RA-18-014

February 13, 2018

Oyster Creek Nuclear Generating Station  
Renewed Facility Operating License No. DPR-16  
NRC Docket Nos. 50-219 and 72-15

**Subject:** Response to Request for Additional Information (RAI) and Supplemental Regarding License Amendment Request - Proposed Changes to the Oyster Creek Emergency Plan for Permanently Defueled Emergency Plan and Emergency Action Level Scheme

**Figure 6.1: Exelon Notification Scheme**

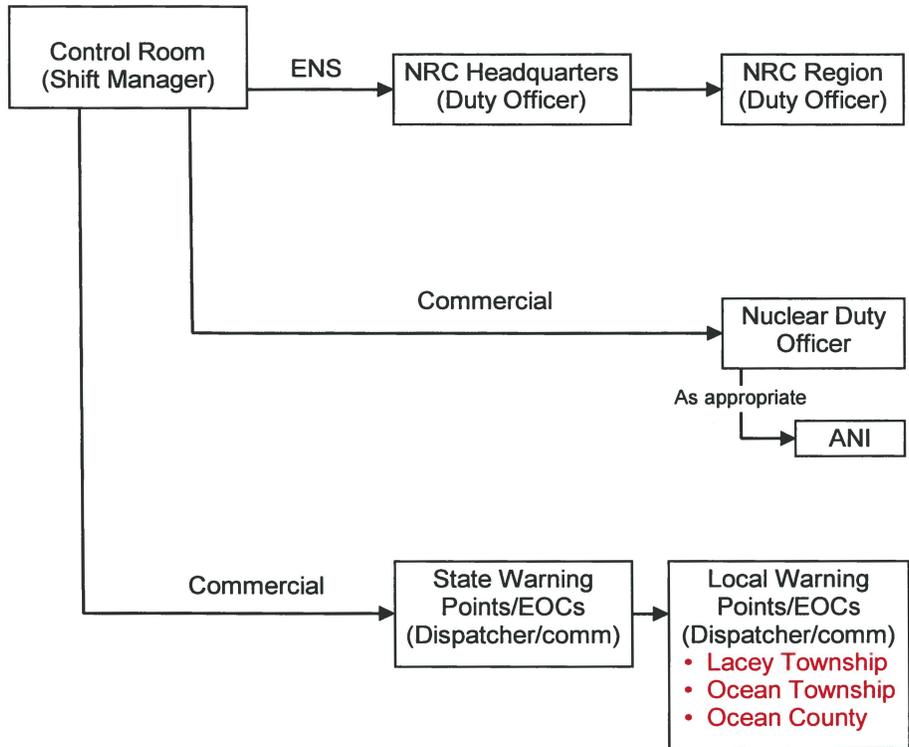
In addition, Figure 6.1, "Exelon Notification Scheme," (page 19) in Attachment 2 of Exelon's August 29, 2017 letter, appears to indicate that the State of New Jersey will provide notification to "Local Warning Points/EOCs [*emergency operations centers*]."

Please clarify which organization local warning points/EOCs will be notified by the State of New Jersey in the event of an emergency declaration at OCNCS, and whether there is agreement with these local response organizations, specifically Ocean County, on this approach.

**Exelon's Response to RAI-OC-3:** Local organization EOCs: Ocean County, Lacey Township, and Ocean Township are notified by the State of New Jersey, as necessary, when an Unusual Event, Alert, or other State EOC notification has been made by the OC Shift Manager. The local county and townships have established this process for the current operating plant and will continue to support this method during this decommissioning period. The Local Warning Points/EOC block on Figure 6.1 has been revised to indicate the three local EOCs that will be contacted by the State EOC in the attached revised PDEP.
